**ADDENDUM No. 1**

Date: January 27, 2015

Project Name: 3<sup>rd</sup> Street Reconstruction Phase 4 – Guadalupe St. to Nueces St.

C.I.P. No.: 8158.004

**CITY OF AUSTIN, TEXAS**  
**DEPARTMENT OF PUBLIC WORKS**  
**ENGINEERING SERVICES DIVISION**  
**3RD ST. RECONSTRUCTION**  
**PHASE 4 - GUADALUPE ST. TO NUECES ST.**  
**TRAFFIC CONTROL PLAN - RECONSTRUCTION**  
**PHASE 1**

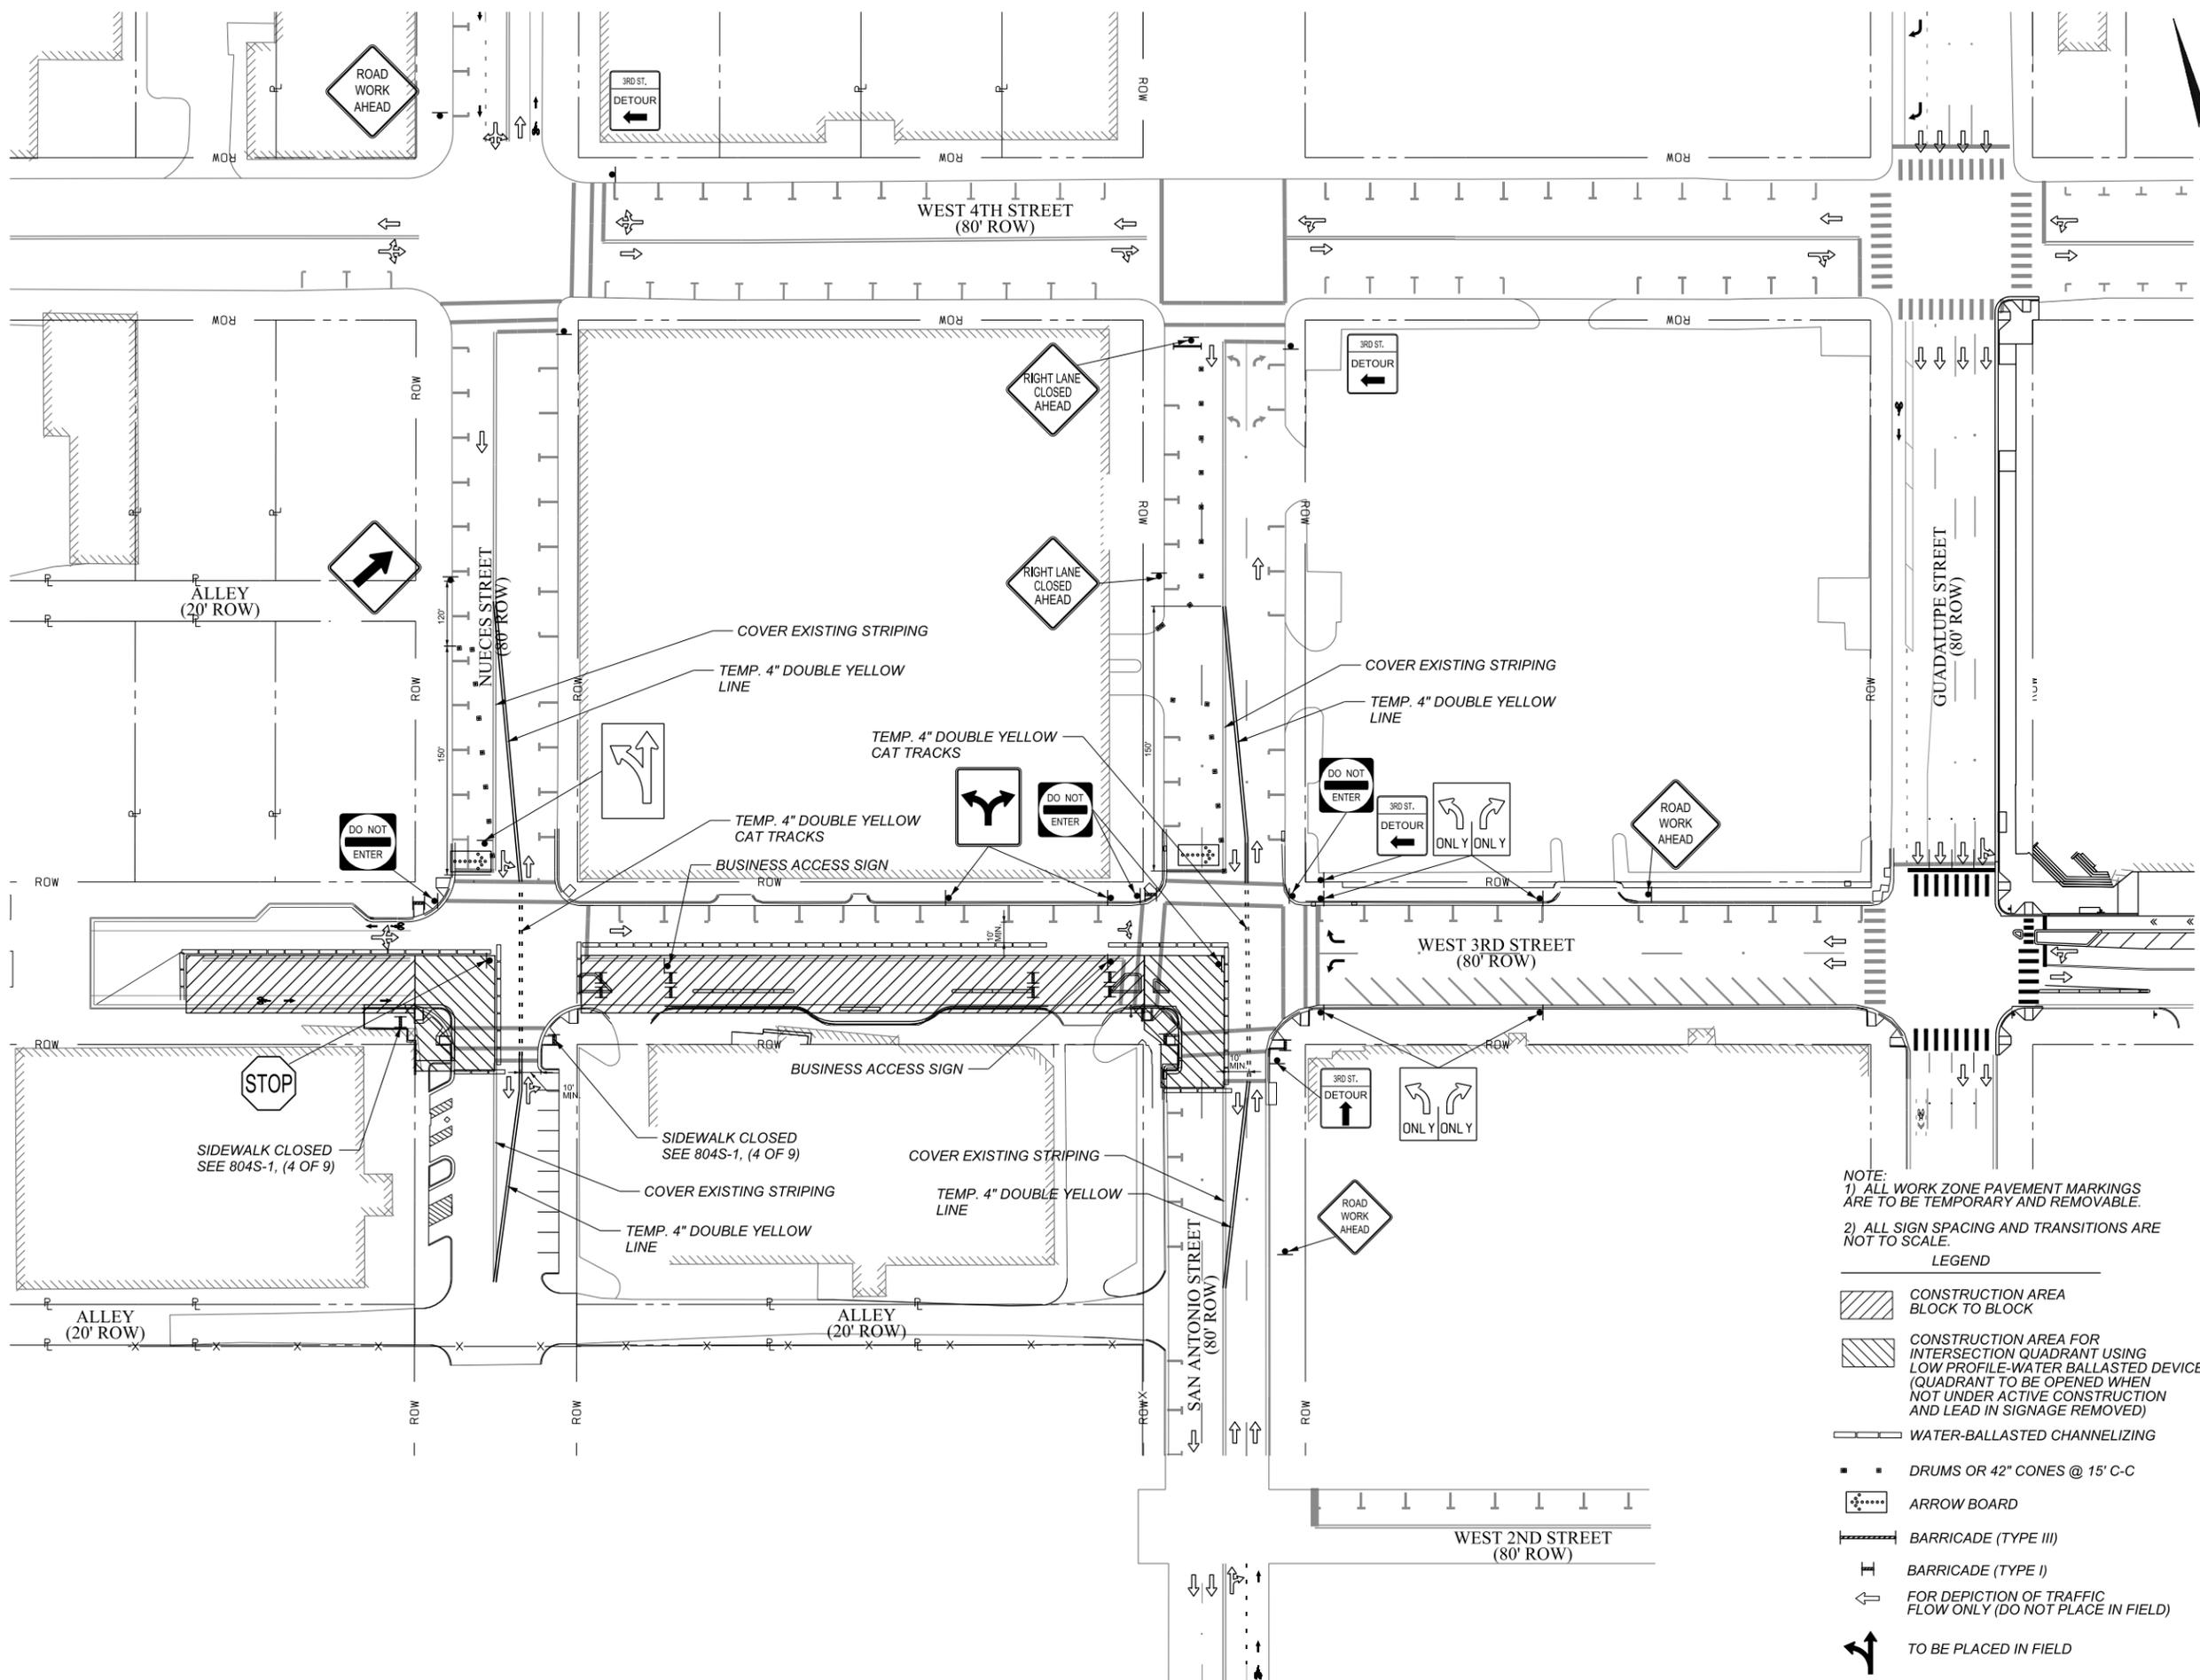
REV. NO.	DATE	REVISION DESCRIPTION
ADD FR	01/27/15	ADDENDUM I: TITLE / PHASE CHANGE

**CITY OF AUSTIN, TEXAS**  
**DEPARTMENT OF PUBLIC WORKS**  
**ENGINEERING SERVICES DIVISION**  
**3RD ST. RECONSTRUCTION**  
**PHASE 4 - GUADALUPE ST. TO NUECES ST.**  
**TRAFFIC CONTROL PLAN - RECONSTRUCTION**  
**PHASE 2**

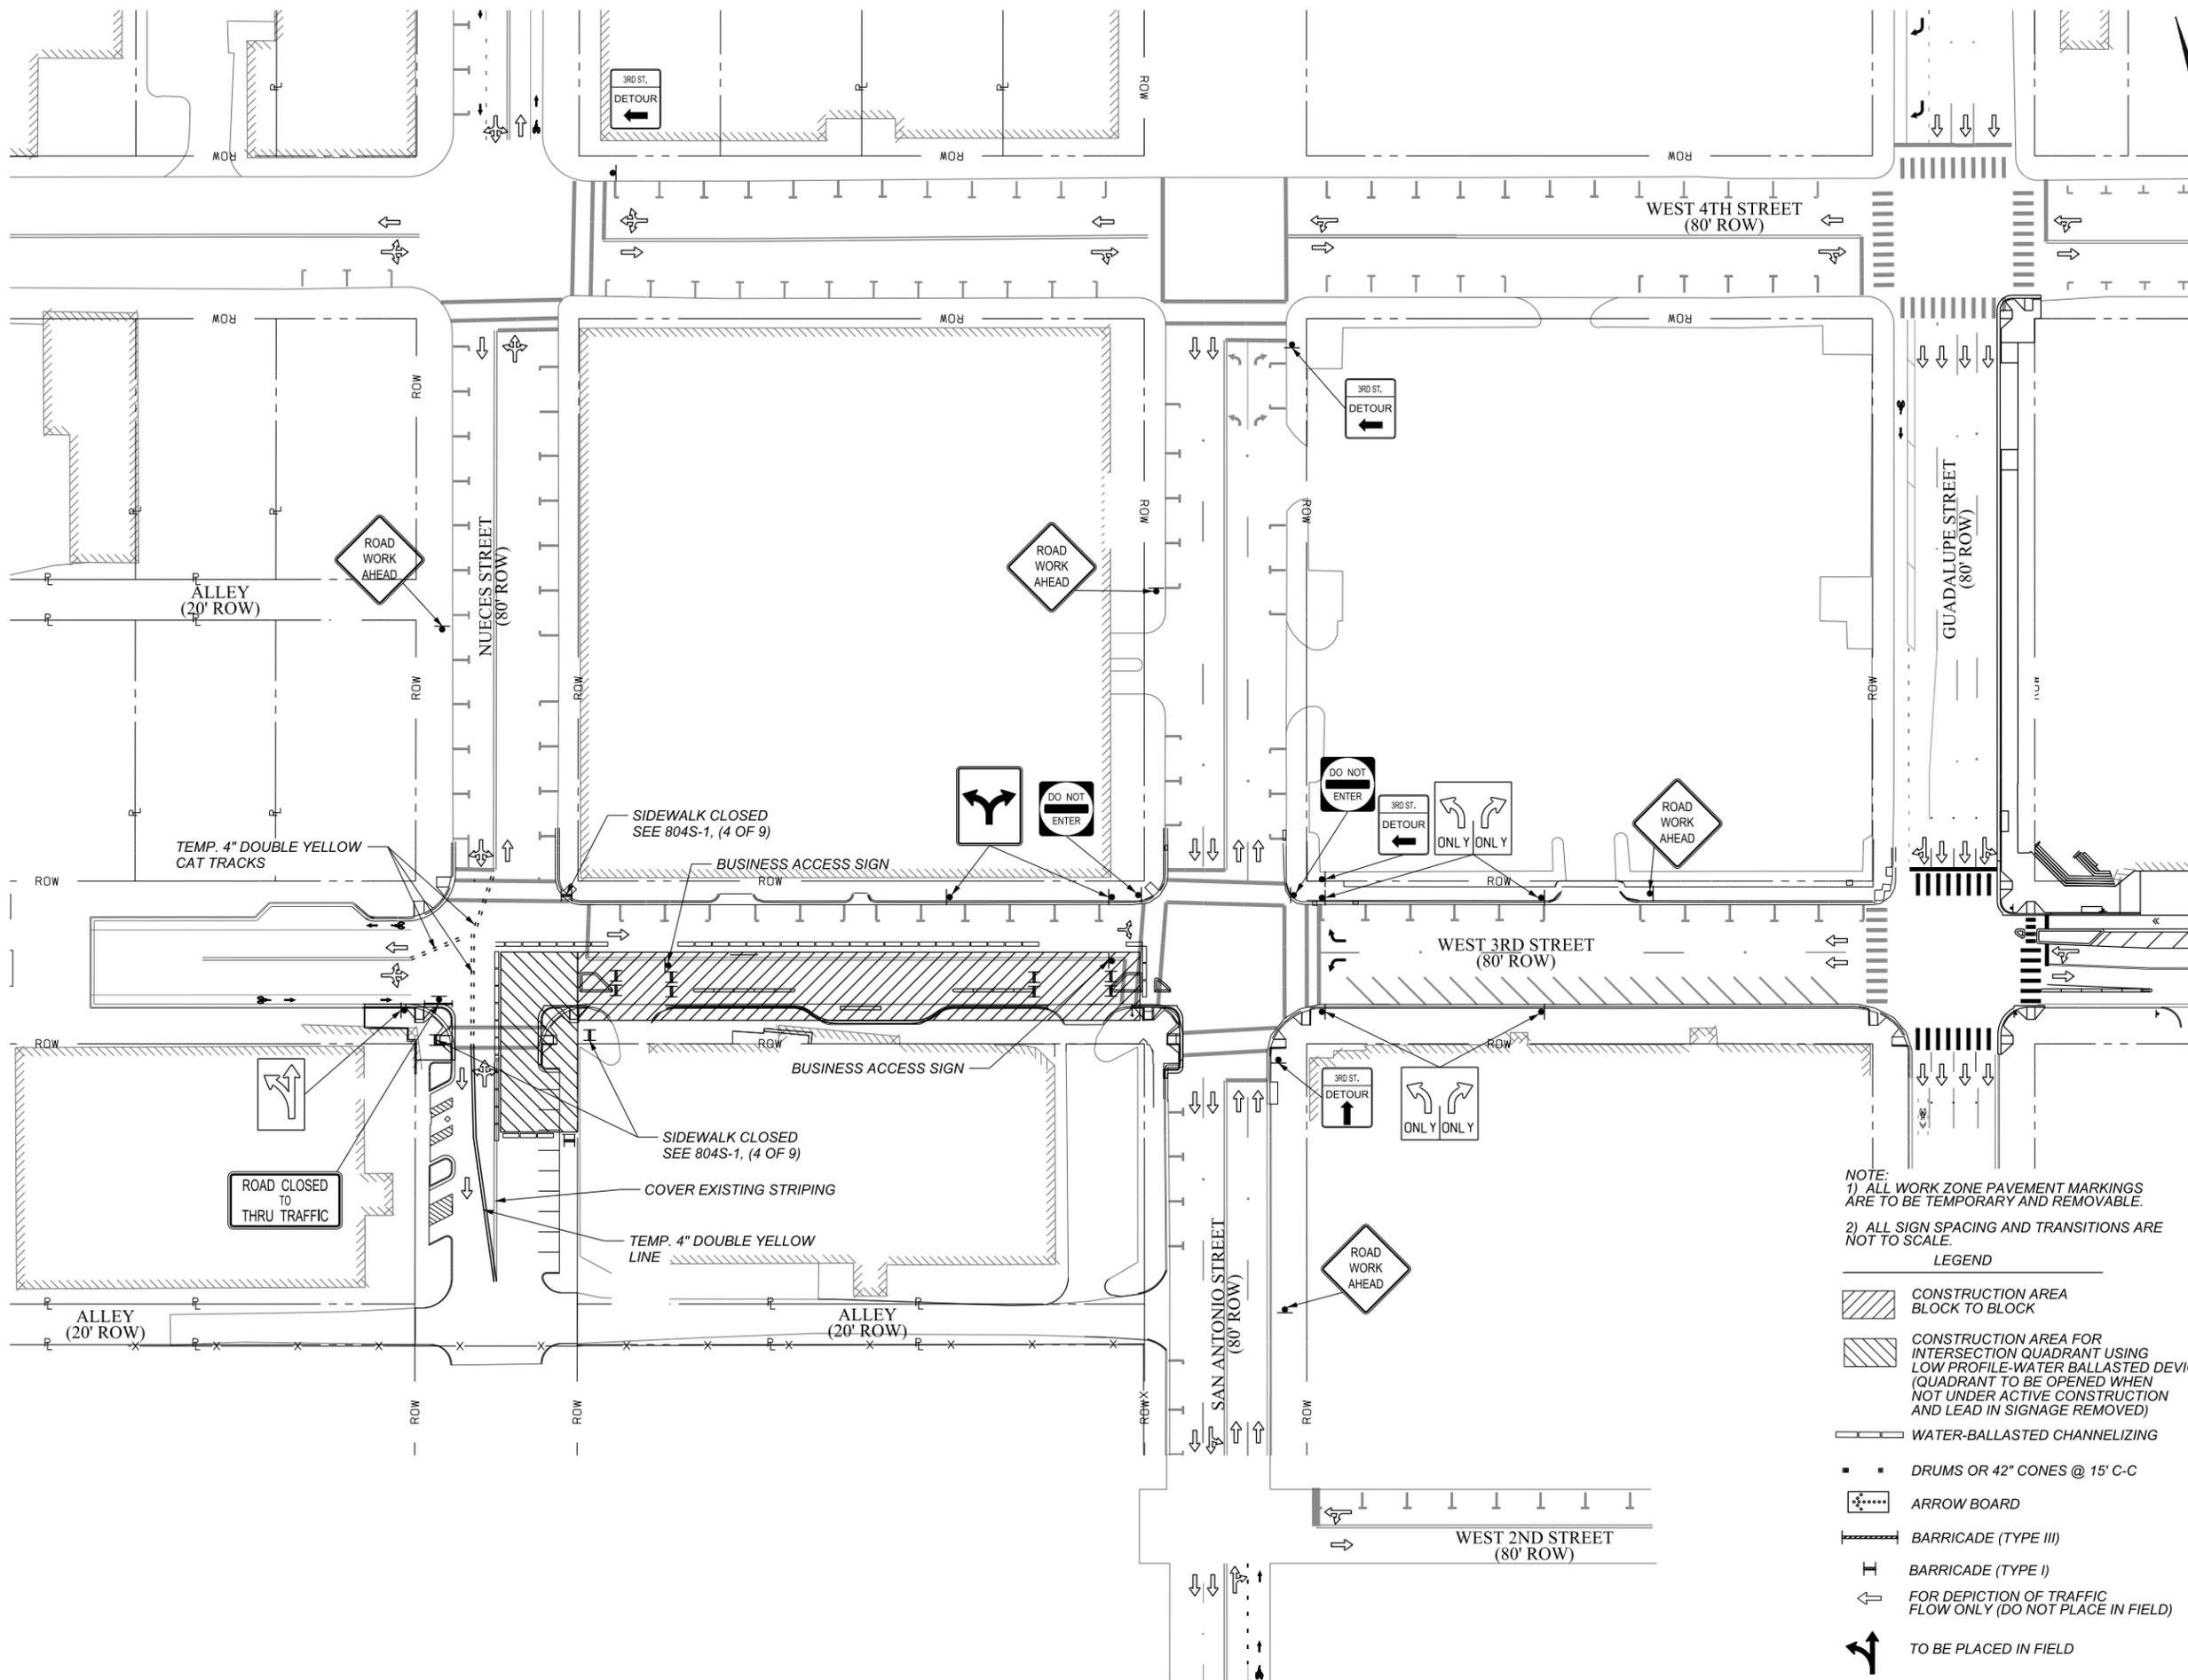
REV. NO.	DATE	REVISION DESCRIPTION
ADD FR	01/27/15	ADDENDUM I: TITLE / PHASE CHANGE

CITY OF AUSTIN, TEXAS  
 DEPARTMENT OF PUBLIC WORKS  
 ENGINEERING SERVICES DIVISION  
 3RD ST. RECONSTRUCTION  
 PHASE 4 - GUADALUPE ST. TO NUECES ST.  
 TRAFFIC CONTROL PLAN - RECONSTRUCTION  
 PHASE 3

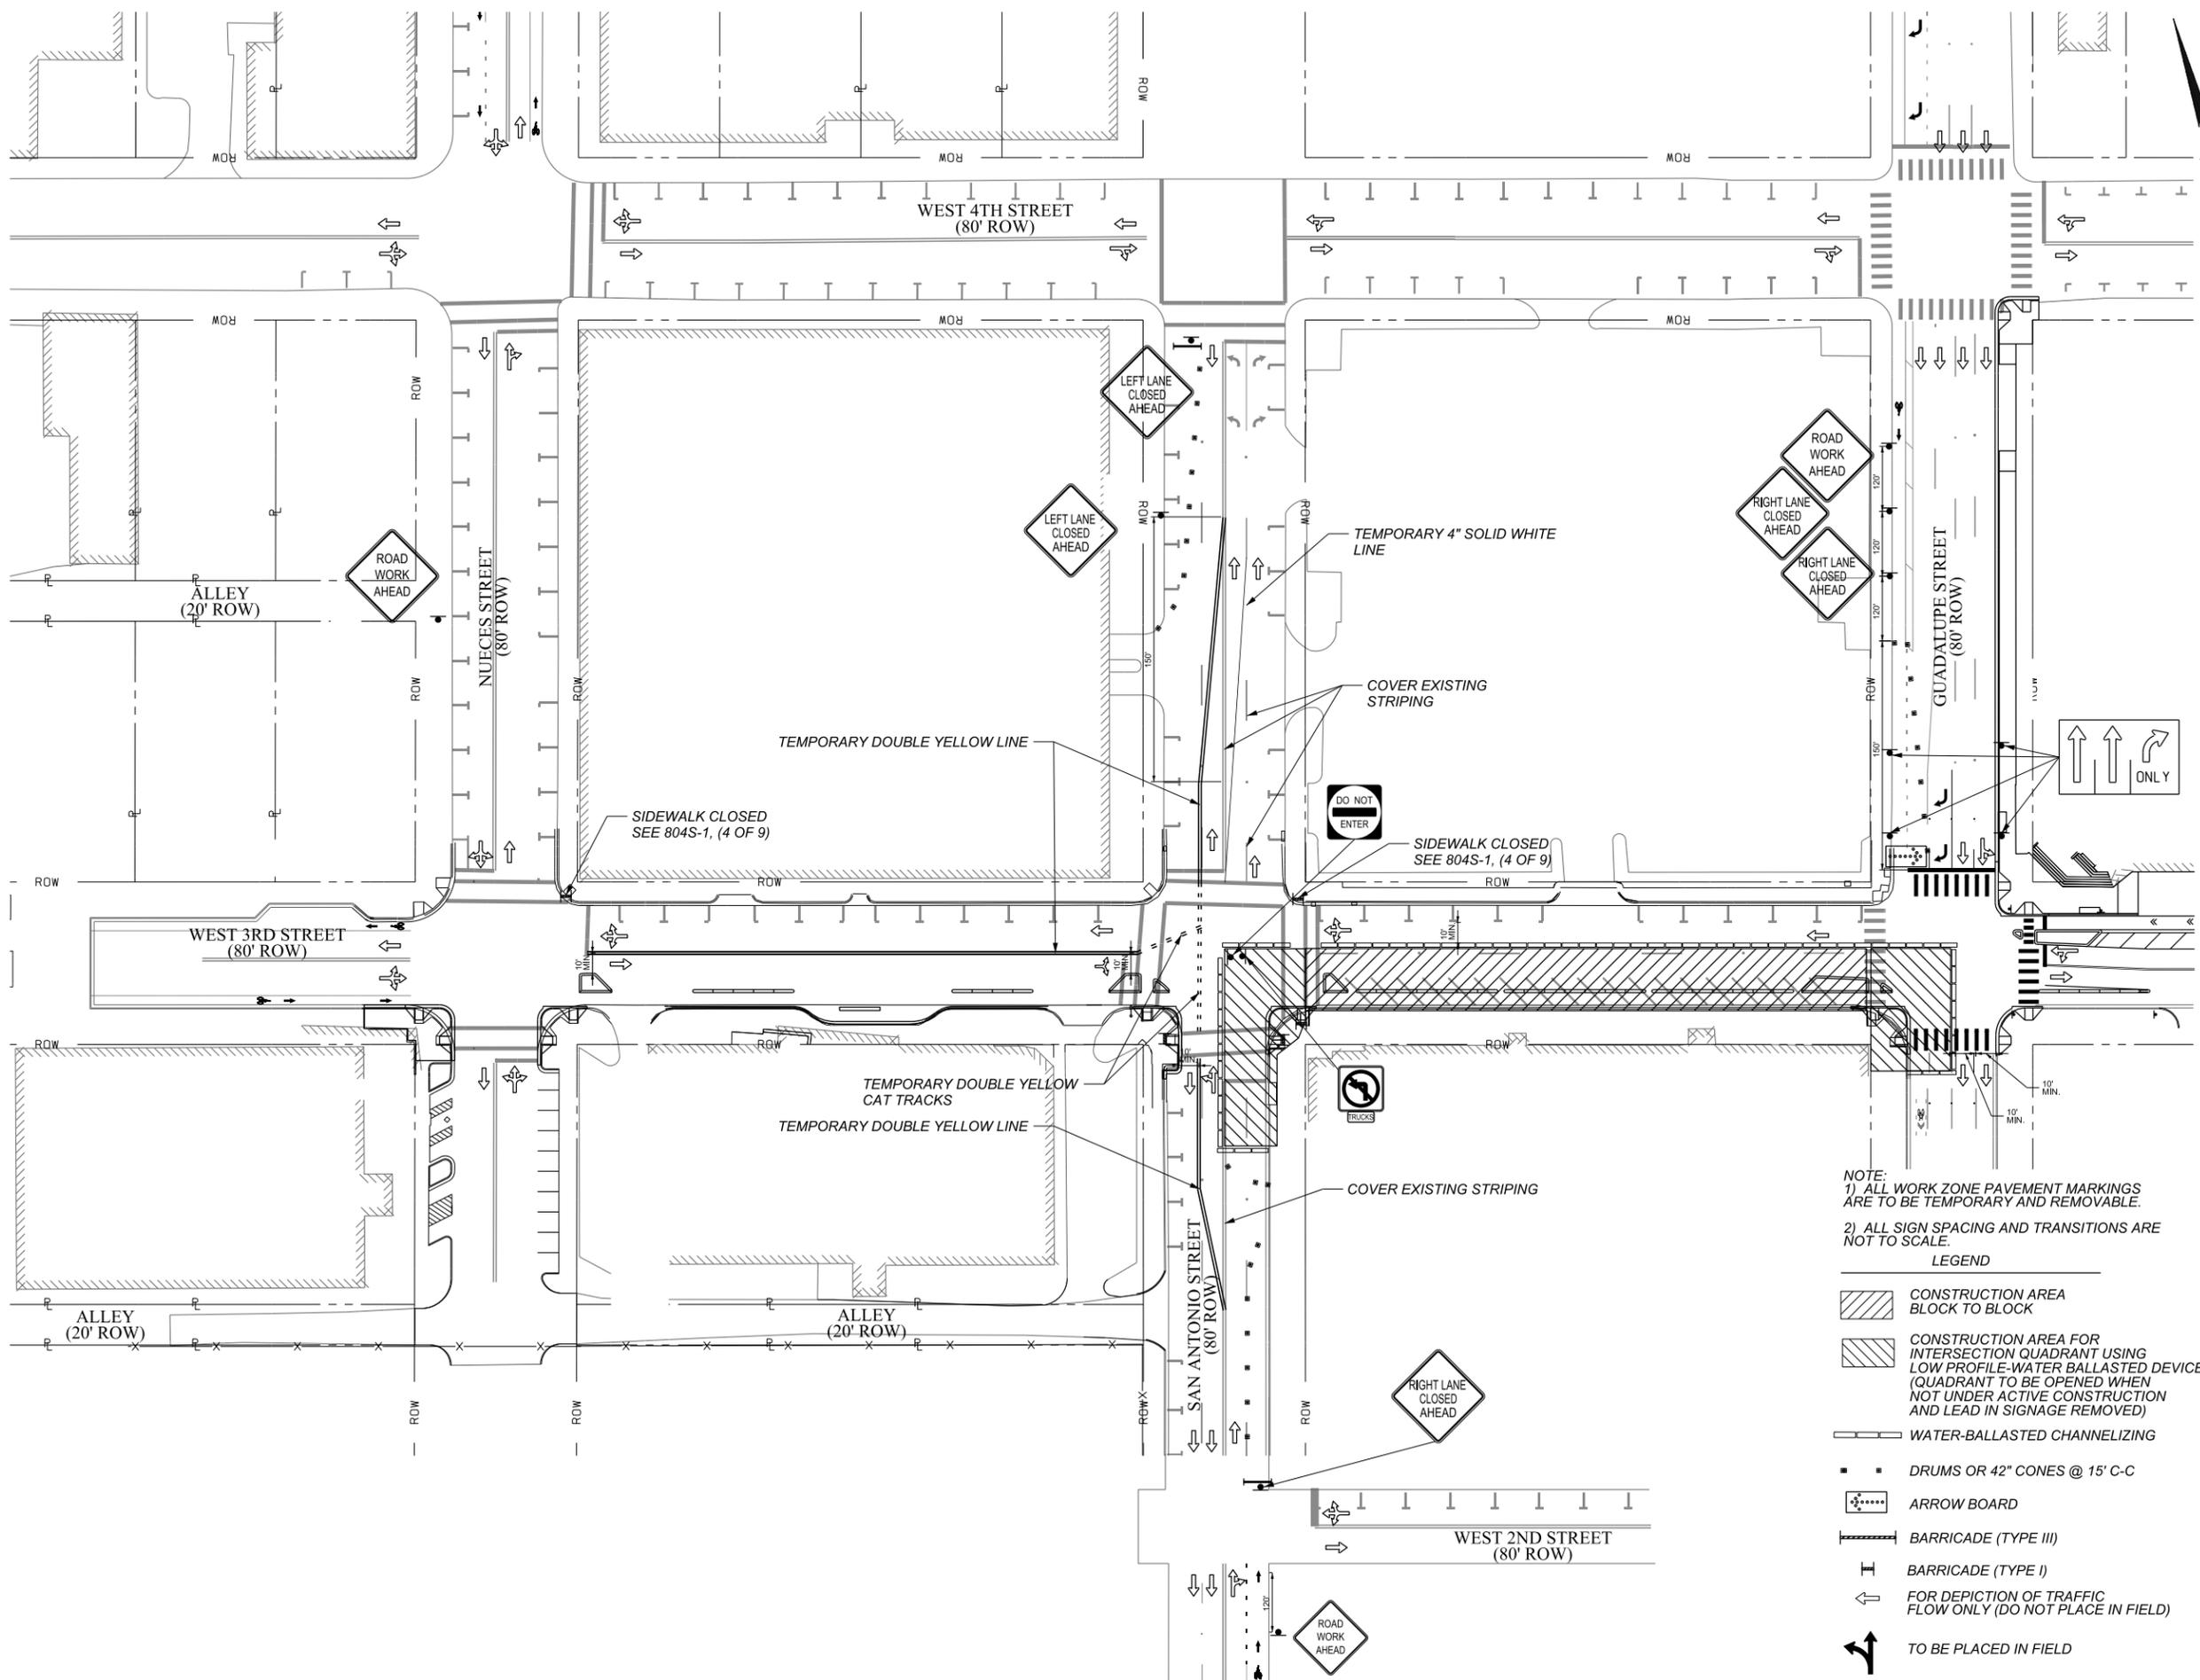
REV. NO.	DATE	REVISION DESCRIPTION
ADD FR	01/27/15	ADDENDUM 1: TITLE CHANGE
